### REGIONAL REVIEW NOTIFICATION

Name of Proposal: NS Logistics South DRI 3497
Submitting Local Government: City of Locust Grove

# NS LOGISTICS CENTER SOUTH DRI City of Locust Grove Natural Resources Group Review Comments

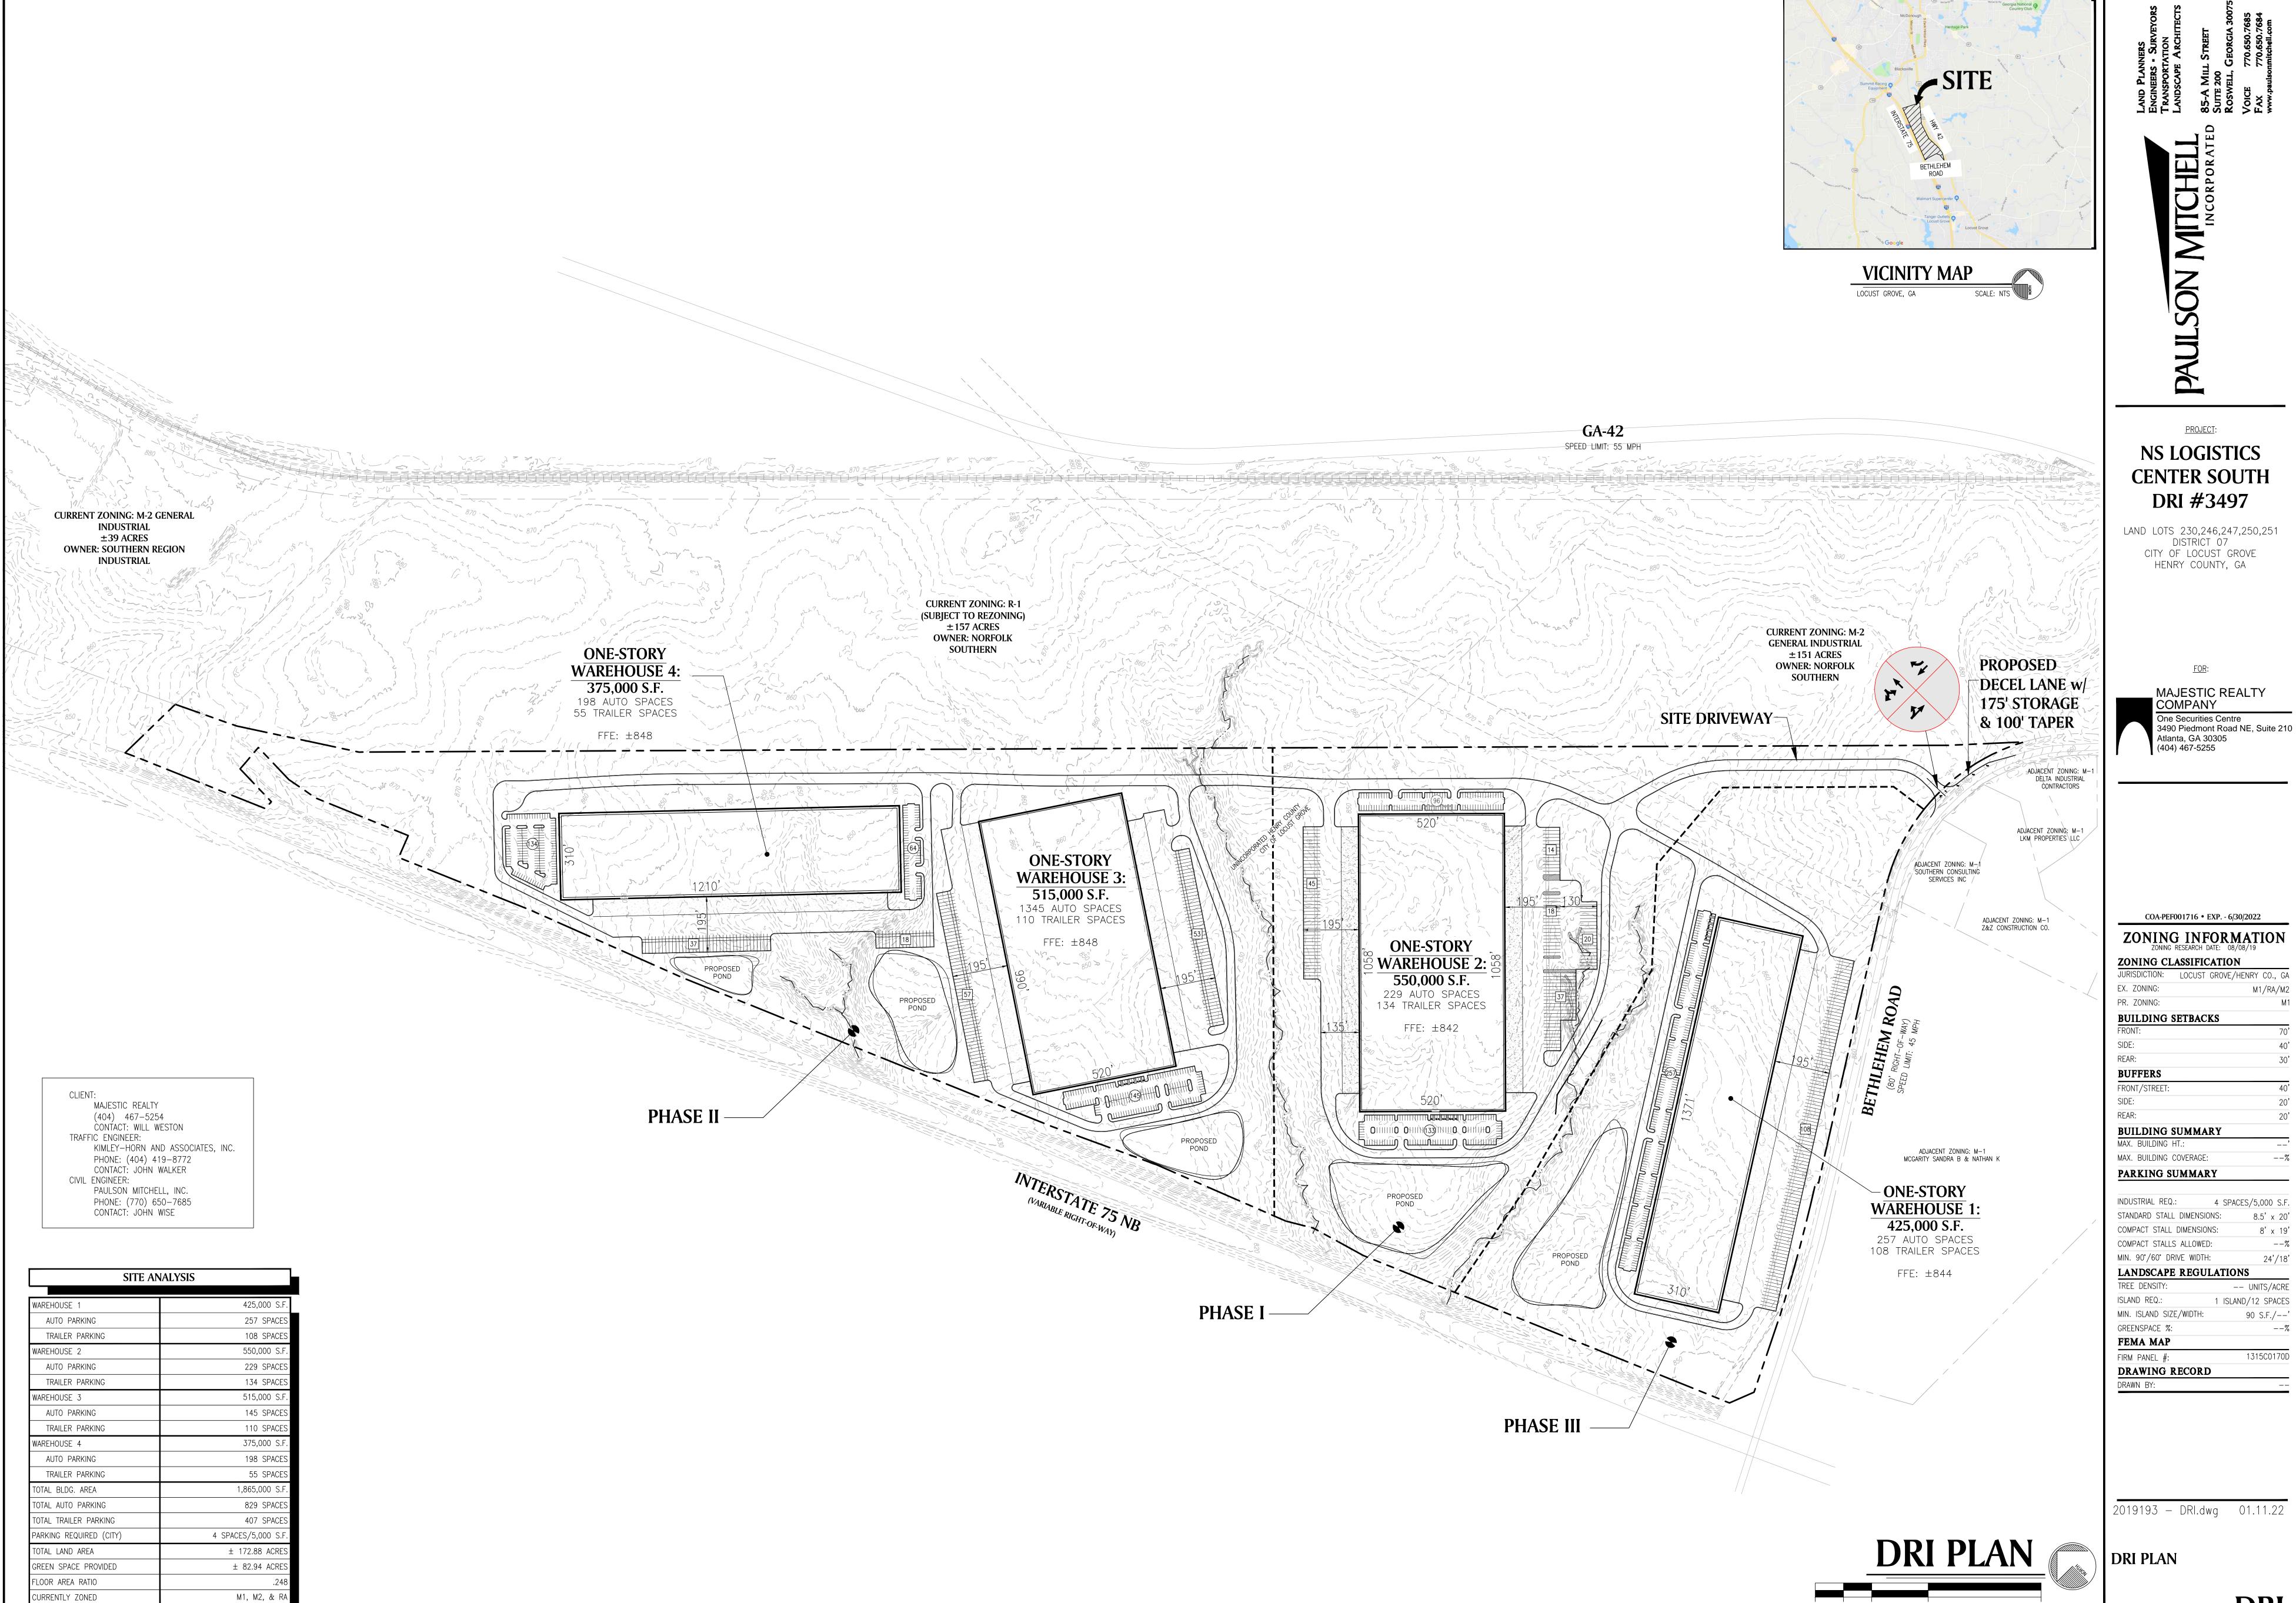
Both the USGS coverage for the project area and the project site plan show two intermittent blue line streams running across the property and I-75 to an unnamed tributary of Indian Creek (which is not on this site). A third stream is shown on the submitted site plan that does not appear on the USGS coverage. However, the site plan does not show the 50-foot buffer and 75-foot impervious setback required under the City Stream Buffer Ordinance or the 25-foot State Erosion and Sedimentation Act buffer. If the streams shown on the site plan meet the requirements for the City and State buffers, the buffers should be shown on the plans. The 25-foot State Erosion and Sedimentation Act buffer also should be shown on all streams on the property.

The site plan shows a portion of the proposed parking area for Warehouse Number 2 over a branch off the southernmost stream shown on the property. This parking area as well as any other proposed development in these in its buffers may require variances of the 25-foot State Erosion and Sedimentation Act buffer and the City stream buffers, if they apply. Any unmapped streams on the property may also be subject to the Locust Grove Stream Buffer Ordinance as well as the 25-foot State Erosion and Sedimentation Act buffer. All waters of the state on the property are subject to the 25-foot State Erosion and Sedimentation Act buffer.
